UNITED STATES PATENT AND TRADEMARK OFFICE

APPLICATION NO.	FILING DATE	FIRST NAMED INVENTOR	ATTORNEY DOCKET NO.	CONFIRMATION NO.
10/626,980	07/25/2003	Helmut Laig-Hoerstebroek	054821-0863	4136
26371	7590	07/22/2005	EXAMINER	
FOLEY & LARDNER 777 EAST WISCONSIN AVENUE SUITE 3800 MILWAUKEE, WI 53202-5308			TIBBITS, PIA FLORENCE	
			ART UNIT	PAPER NUMBER
			2838

Office Action Summary

DETAILED ACTION

Fig. 1

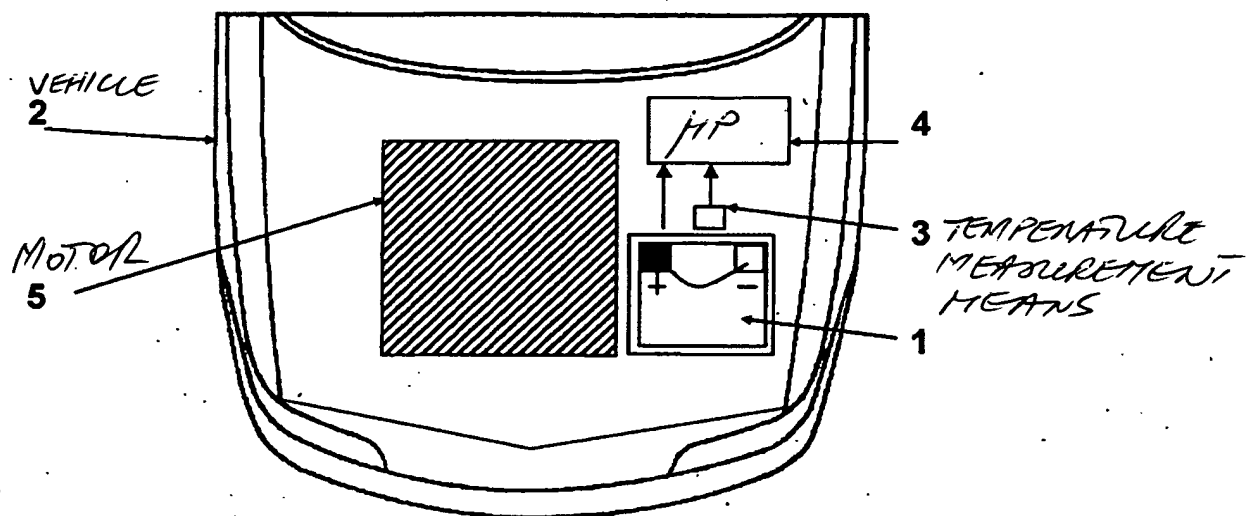
Paper No(s)/Mail Date <u>4/11/2005</u> . | 6) <input checked="" type="checkbox"/> Other: <u>amended fig. 1</u> . |

1. The drawings are objected to under 37 CFR 1.83(a) because they fail to show the conventional names, as described in the specification, e.g. vehicle, motor, temperature measurement means, etc. for the elements shown in fig.1 with non-conventional symbols. Corrected drawings in compliance with 37 CFR 1.121(d) are required in reply to the Office action to avoid abandonment of the application. The replacement sheet(s) should be labeled "Replacement Sheet" in the page header (as per 37 CFR 1.84(c)) so as not to obstruct any portion of the drawing figures. If the examiner does not accept the changes, the applicant will be notified and informed of any required corrective action in the next Office action. The objection to the drawings will not be held in abeyance.
